## SERVICE ADVISORY # 17-294

### Coleman 1755 Furnace Return Vent

It has been determined that on some 2017-2018 Coleman 1755 models built in plant 840, a furnace return vent was not installed. This advisory explains how to correct the problem if it exists.

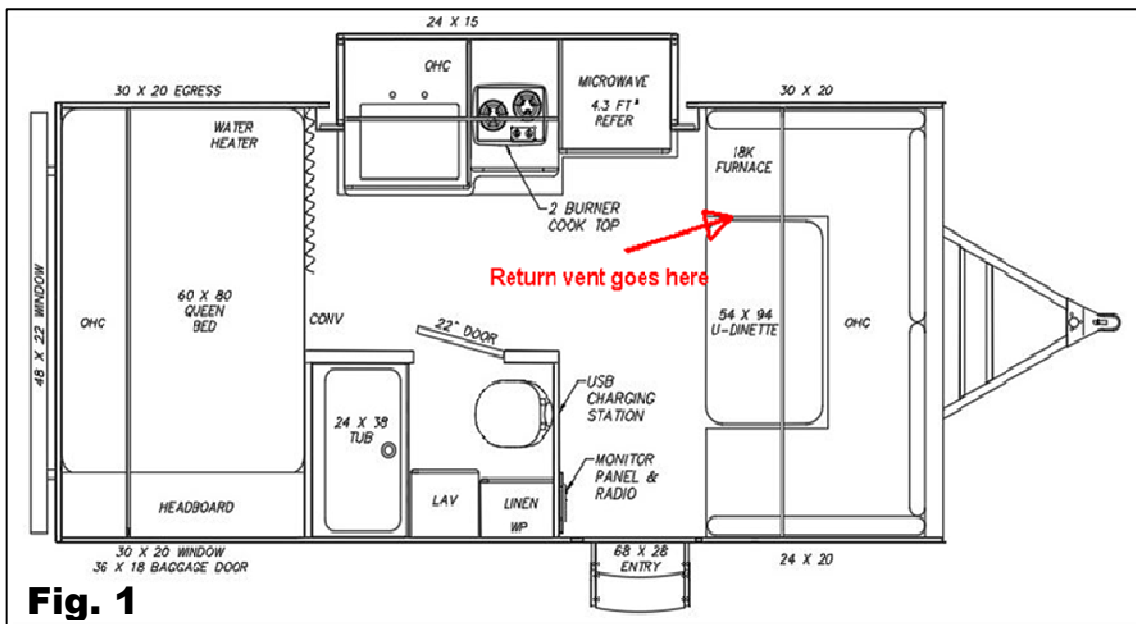
Locate the furnace under the dinette seat on the off-door-side towards the front of the unit, Figure 1.
